ADDENDUM NO. 4

Addendum Date: July 2, 2026

Bid Number: EDA # ED24AUS0G0115

Project: Copperas Cove EDC 45 Acre Industrial Park

1 LIFT STATION WETWELL AND PUMP DETAIL
SCALE: N.T.S.

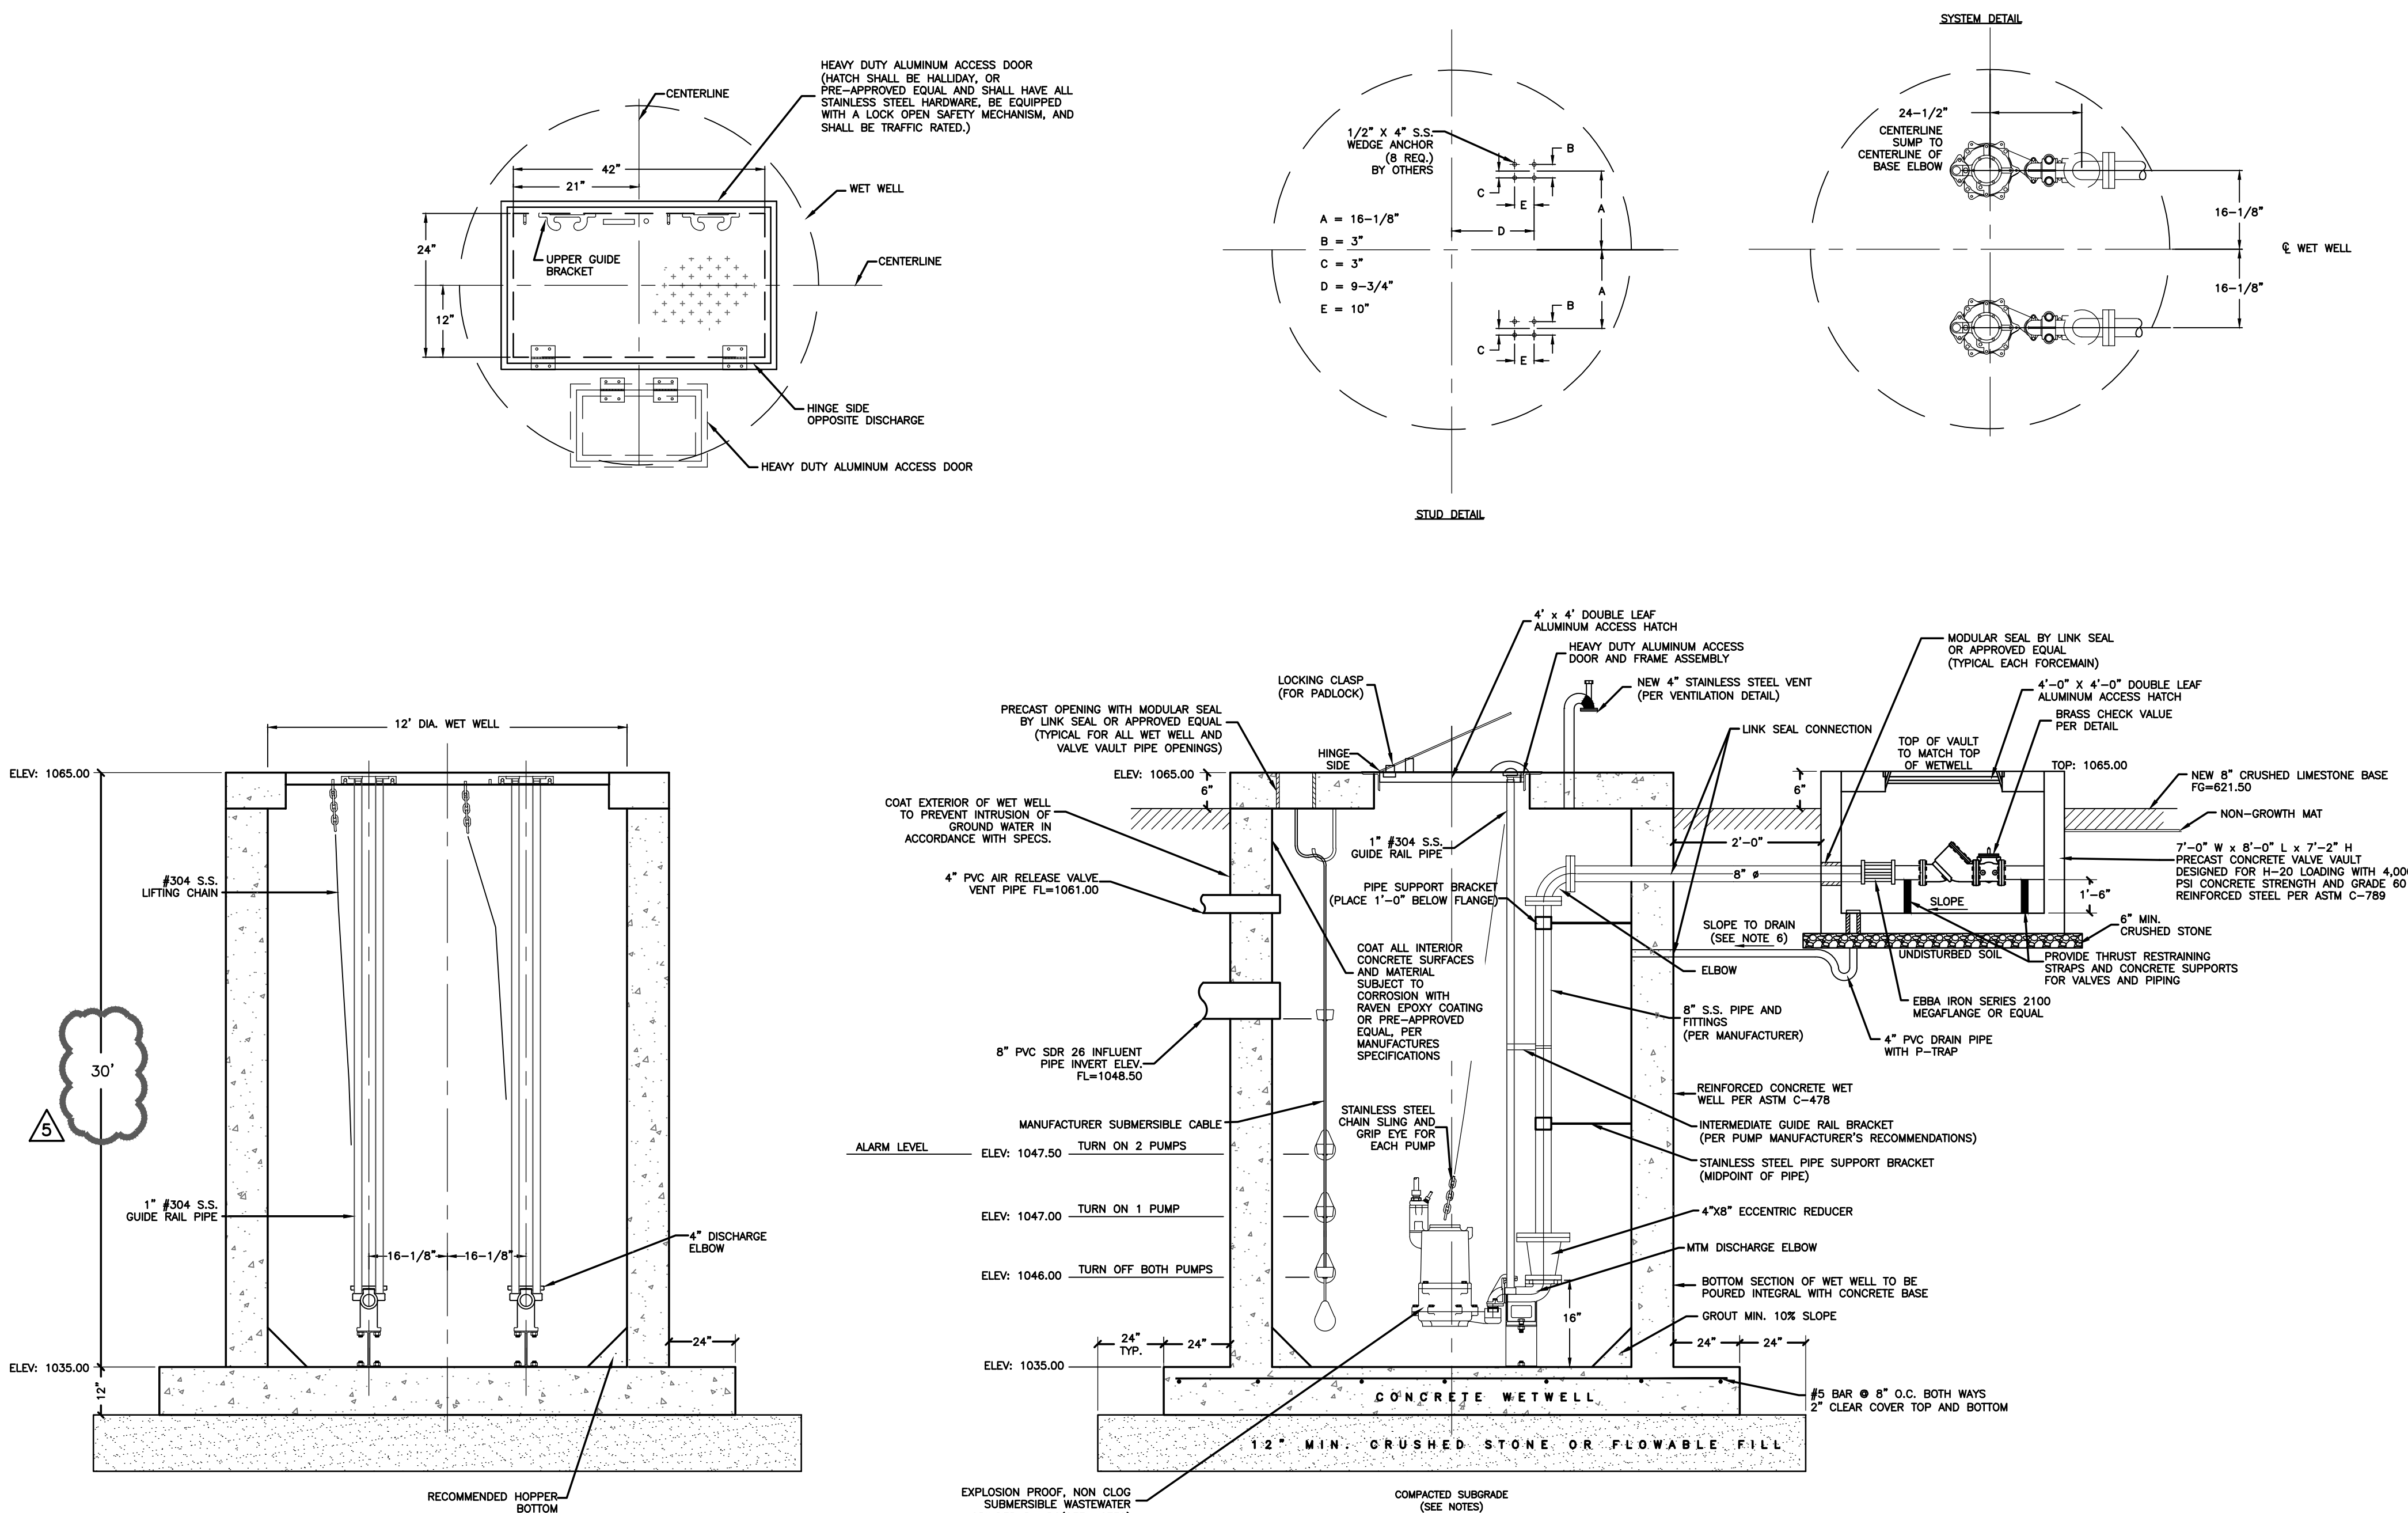
Item #1: Revised Sheet C14.2 provided. Depth of Wet Well Dimension corrected.
